ECN/PCN No.: 3452

For Manufacturer		
Product Description: LOW FREQUENCY CYLINDRICAL WATCH CRYSTAL	Abracon Part Number / Part Series: AB38T	<input checked="" type="checkbox"/> Series <input type="checkbox"/> Part Number
Affected Revision: I	New Revision: J	<input type="checkbox"/> Safety <input checked="" type="checkbox"/> Non-Safety

Dimension Table	
A	Ø 3.2 MAX
B	8.3 MAX
C	8.0 MIN
D	0.8 ± 0.3
E	Ø 0.34 ± 0.2

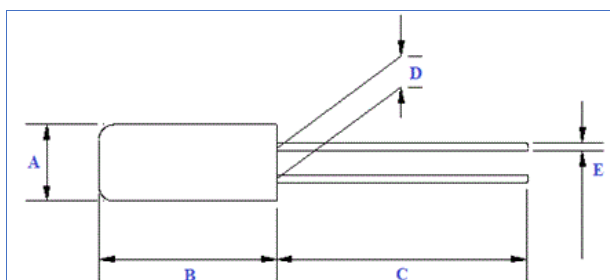
1. Electrical performance
 - a. Frequency Coefficient (β):
 - i. Min = -0.040 ppm/T²
 - ii. Typ = -0.034 ppm/T²
 - iii. Max = -0.028 ppm/T²
 - b. Aging specification @25°C±3°C (First year) for “other frequencies” outside of 32.768kHz:
 - i. ± 5ppm
2. Mechanical Dimensions (millimeters)
 - a. Terminal length dimension = 9 MIN
 - b. Length between 2 terminals dimension = 1.1
 - c. Terminal radial dimension = Ø 0.35

1. Electrical performance
 - a. Frequency Coefficient (β):
 - i. Typ = -0.035±0.01 ppm/°C²
 - b. Aging specification @25°C±3°C (First year) for “other frequencies” outside of 32.768kHz:
 - i. Specification removed entirely. This part is not offered at any “other frequency” outside of 32.768kHz anymore.
2. Mechanical Dimensions (millimeters)
 - a. Terminal length dimension = 8 MIN
 - b. Length between 2 terminals dimension = 0.8 ± 0.3
 - c. Terminal radial dimension = Ø 0.34 ± 0.2
